APPLICATION

PERCOLATION TESTING

HOWARD COUNTY HEALTH DEPARTMENT
BUREAU OF ENVIRONMENTAL HEALTH
3525-H ELLICOTT MILLS DRIVE/ELLICOTT CITY, MARYLAND 21043
TELEPHONE: 313-2640

SUBDIVISION MEADOW WOOD LOT NO. 39

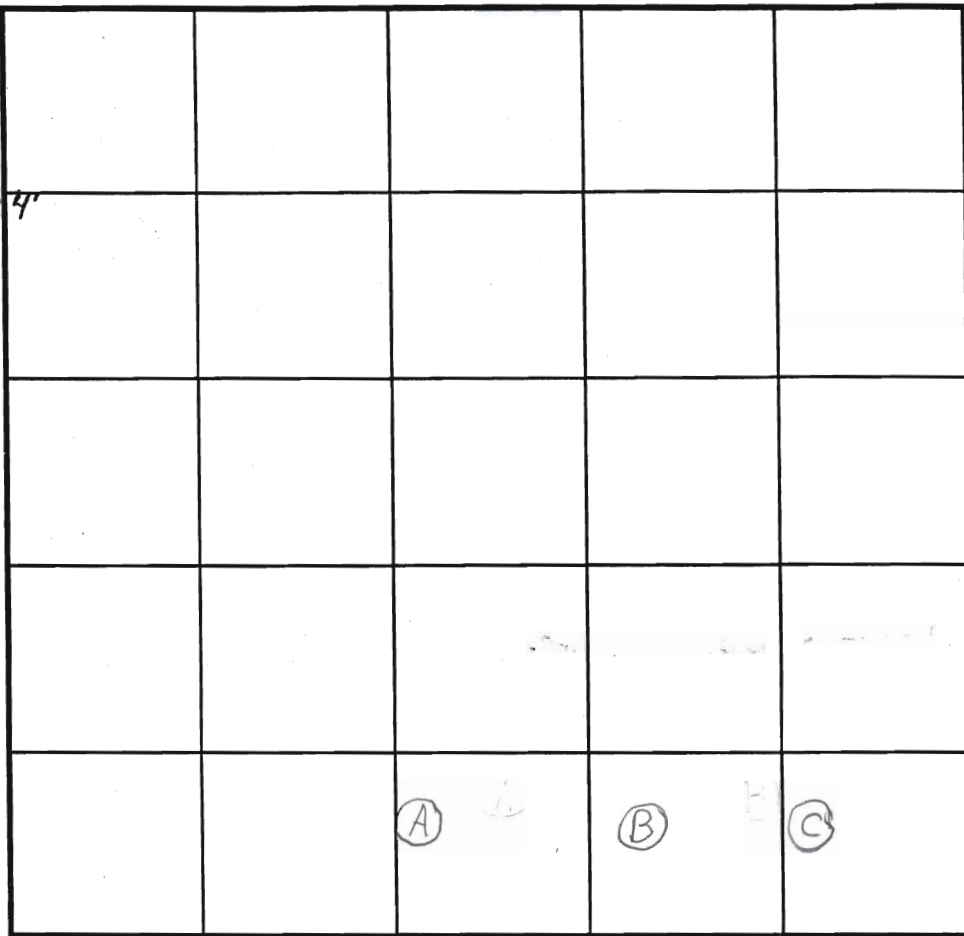
REMARKS System as shallow as possible due to fast
 TYPE OF SOIL perc rates
 TESTED BY B. Baker ALSO PRESENT _____
 TRENCH DESIGN DATA: AVERAGE PERCOLATION TIME _____ TRENCH WIDTH _____
 INLET DEPTH 1.5' MAXIMUM BOTTOM DEPTH 3.0' SQ. FT./BEDROOM _____

SITE PLAN

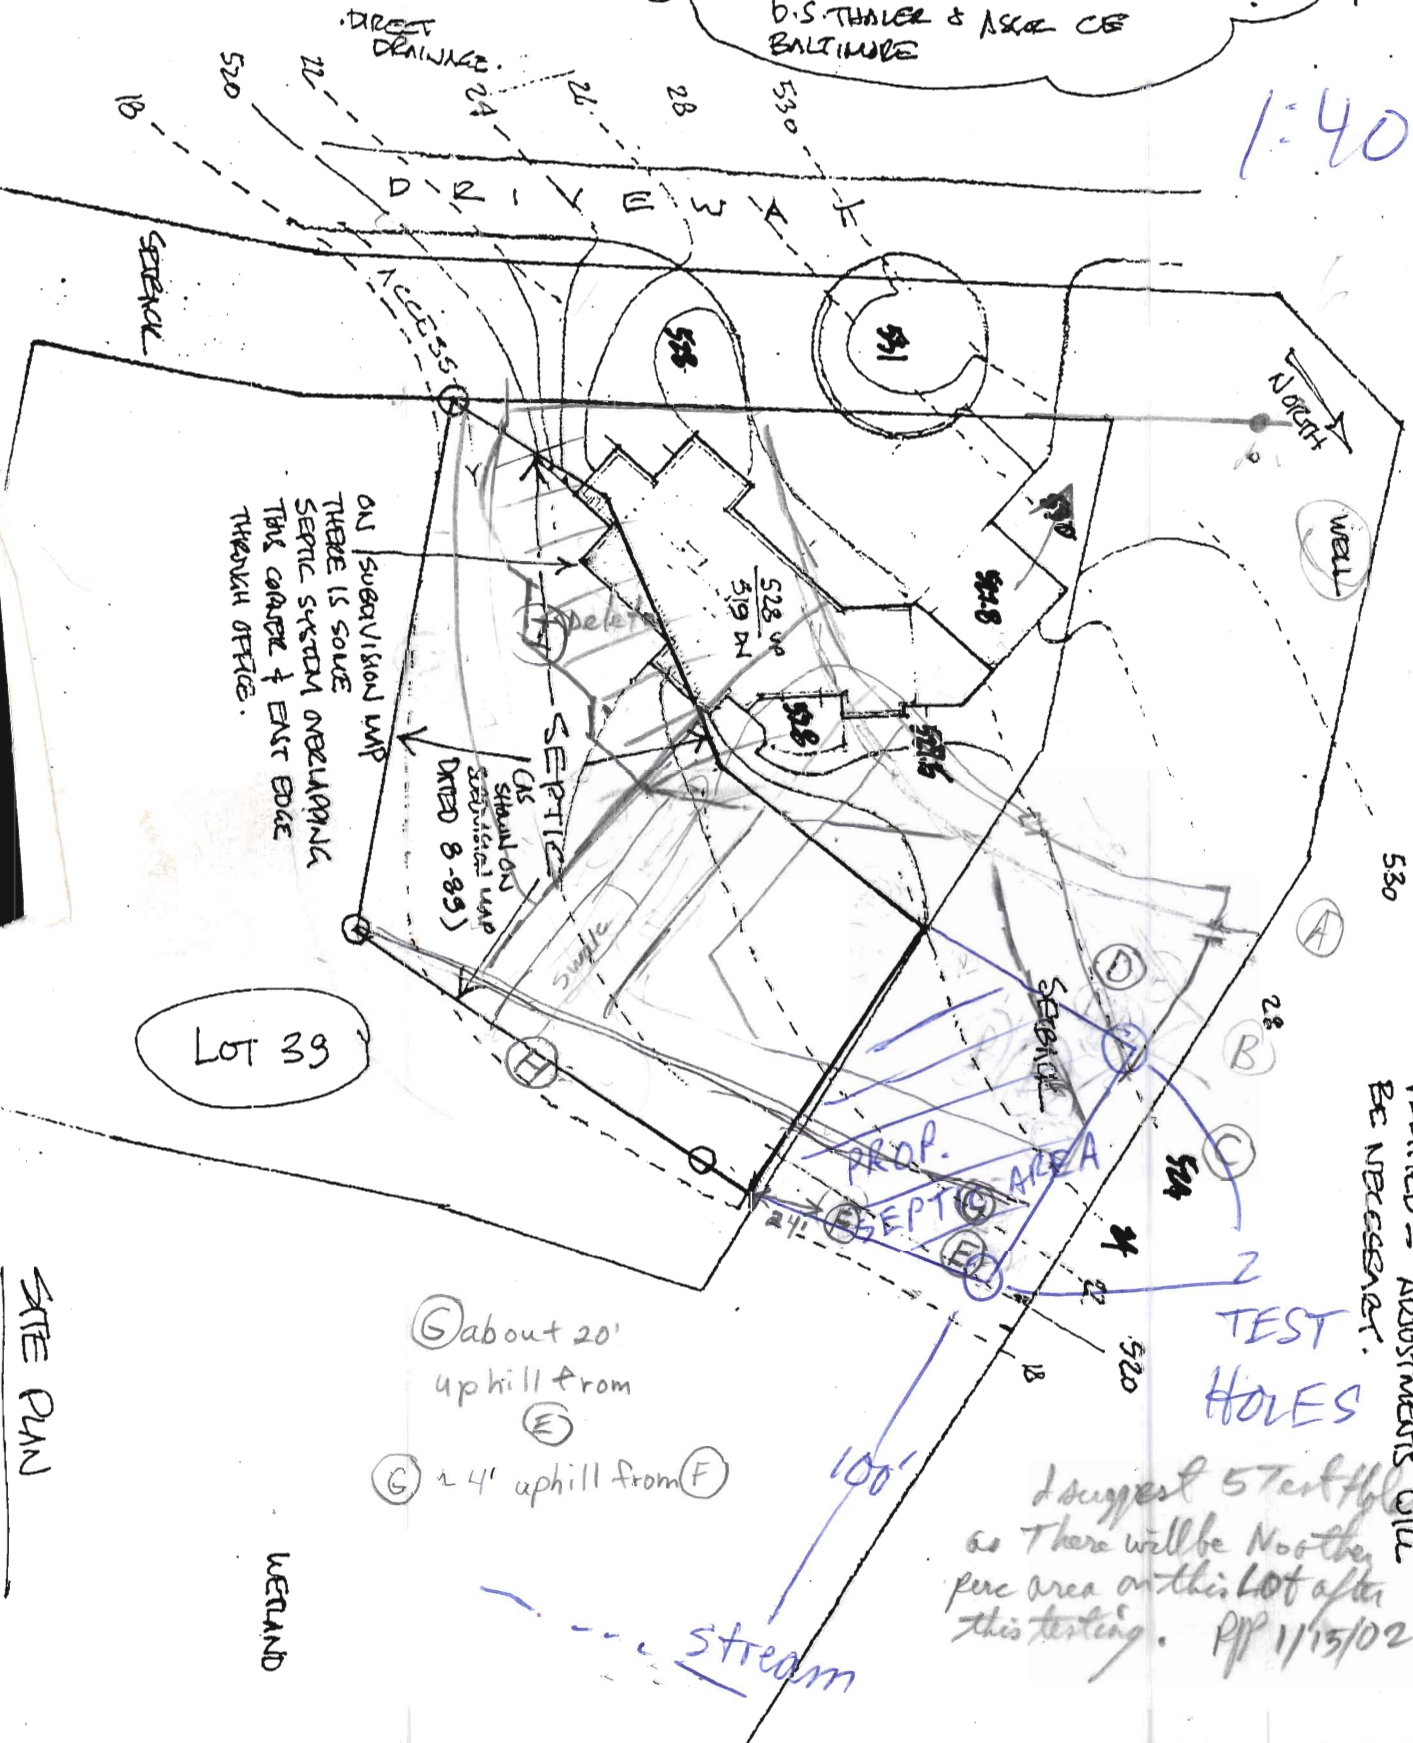
To: House to be moved
downhill. Easement to be
moved uphill. Surveyor/
Engineer needs to locate new
test holes, get topography -
especially around house site and
swale, locate well, submit new
plan. Low holes that were tested
in easement had rock/water.

I suggest More than two
perc Holes as shown. old Test
Hole #4 is under house and
Test hole #5 is >125 ft from other
and No Test Holes in any upper
portion

ON SUBDIVISION MAP
THERE IS SOME
SEPTIC SYSTEM OVERLAP
THIS CAN BE & EAST EDGE
THROUGH OFFICE.

I suggest 5 test holes
so there will be no other
prop area on this lot after
this testing. P/P 11/15/02

(G) about 20'
uphill from
(E)
(G) 24' uphill from (F)

BB
Revised Perc Plat
Approved BB
